## BP'S RESPONSE TO DEADLINE 8

## Deadline 8 submission

**ANNEX 2  
BP'S COMMENTS ON THE NSTA REPORT AND RESPONSE TO SEWELL FURTHER  
SUBMISSIONS**

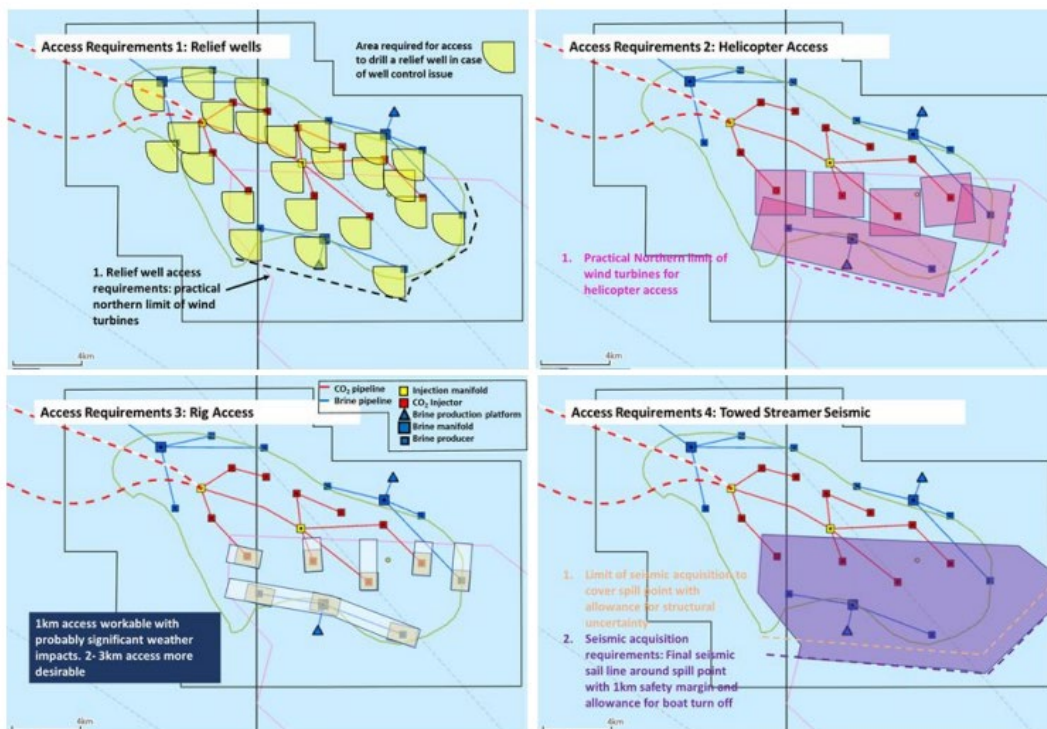
- 2.3 In finding that periodic access to carbon storage infrastructure within an offshore windfarm is a “*significant obstacle*” and that “*Consequently, largely overlapping carbon storage sites and wind farms are presently considered not to be feasible with current technology*”, the NSTA Technical Report identifies and discusses a number of “*operational scenarios*” which take account of various activities typically required for a CCS project operating in a marine environment, which include issues addressed in bp’s report “A Technical Assessment of

<sup>1</sup> The Exclusion Area included in bp’s protective provisions accounts for ~45% of the Endurance store seabed area and ~25% of the H4 developable seabed area.

the Endurance Reservoir and Hornsea Project Four Wind Farm” (the “bp Technical Assessment “) submitted in this DCO examination process as part of the Joint Position Statement of Orsted and bp submitted at Deadline 1 such as support vessels, well heads, aviation and temporary installations.<sup>2</sup> The NSTA’s comments, which are consistent with bp’s discussion of specific access requirements for Endurance, include the following (on Slide 13):

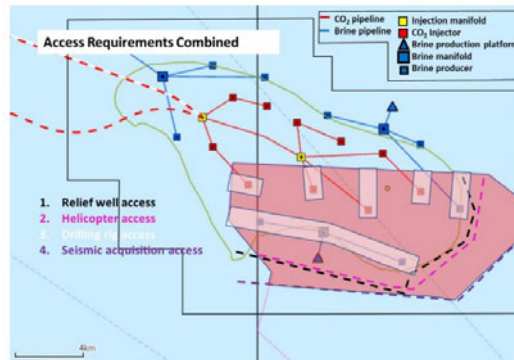
2.5 bp previously explained in detail why and how access requirements are necessary for developing and operating the Endurance Store and why, as a result, co-existence in the Exclusion Area is not feasible. This is illustrated in bp’s Technical Assessment Report ([REP1-057](#), section 9 (Figures 36/37), p.201) by showing the individual requirements and combined impact on the Exclusion Area (extracts shown below).

All five diagrams show clearly that the combined area required for each of these operational activities results in there being no ability to locate any turbines within the Exclusion Area.
